Access Compliance Report Public Rights-of-Way (Curb Ramps)

Main Street: COUSTEAU_LN Cross Street: CLYDESDALE_DR Location: NW

ADA ID: RPRK211110135308 Ramp Type: Type 4 - Parallel Initial Pass/Fail: Fail Overall Compliance: No Severity Score: 16

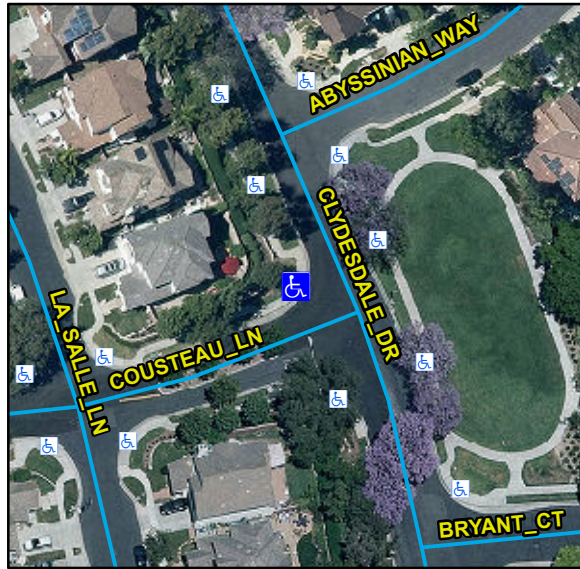
Compliance	Description	Data	Compliance	Description	Data
N/A	Ramp Length LT (in)	139	N/A	Ramp Length RT (in)	138
Yes	Ramp Width LT (in)	53	Yes	Ramp Width RT (in)	53
Yes	Ramp Run Slope LT (%)	0.6	No	Ramp Run Slope RT (%)	10.7
No	Ramp Cross Slope LT (%)	2.8	Yes	Ramp Cross Slope RT (%)	1.1
N/A	Landing Present	N/A	N/A	DWS Provided	N/A
N/A	Landing Length (in)	N/A	N/A	DWS Contrast	N/A
N/A	Landing Width (in)	N/A	N/A	DWS Length (in)	N/A
N/A	Landing Run Slope (%)	N/A	N/A	DWS Full Width	N/A
N/A	Landing Cross Slope (%)	N/A		DWS Offset Type	N/A
N/A	Landing Movement Obstructed?	N/A	N/A	DWS Offset Left (in)	N/A
	Landing Movement Type	N/A	N/A	DWS Offset Right (in)	N/A
N/A	Landing Shared	N/A			
N/A	Clear Space	Yes			
N/A	Clear Space To Crosswalk (in)	N/A			
N/A	Marked Crosswalk 1	No	N/A	Marked Crosswalk 2	No
	Crossing 1 Direction	S		Crossing 2 Direction	E
	Marked Crosswalk 1 Width (in)	N/A		Marked Crosswalk 2 Width (in)	N/A

Remove & Replace Curb Ramp With Two New Directional Ramps or Equivalent.
